## PIC12C5XX Data Sheet Errata

### Clarifications/Corrections to the Data Sheet:

In the Device Data Sheet (DS40139E), the following clarifications and corrections should be noted.

**FIGURE 1: PACKAGING MARKING INFORMATION**

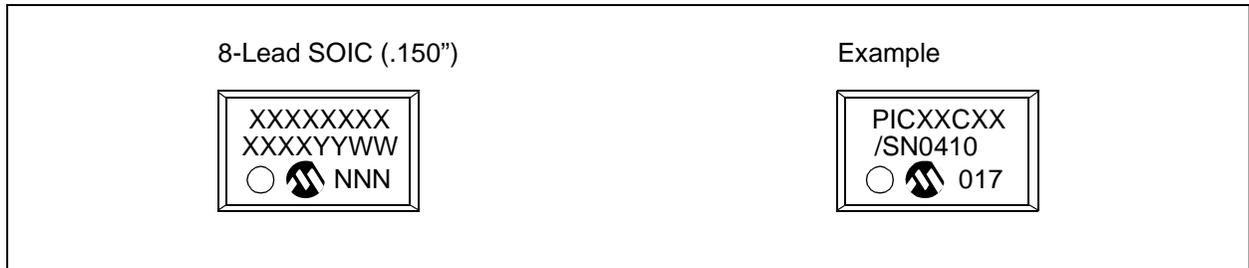
In Section 15.1 "Packaging Marking Information", the marking for the 8-Lead SOIC (150 mil) is incorrect. The correct marking is shown in Figure 1.
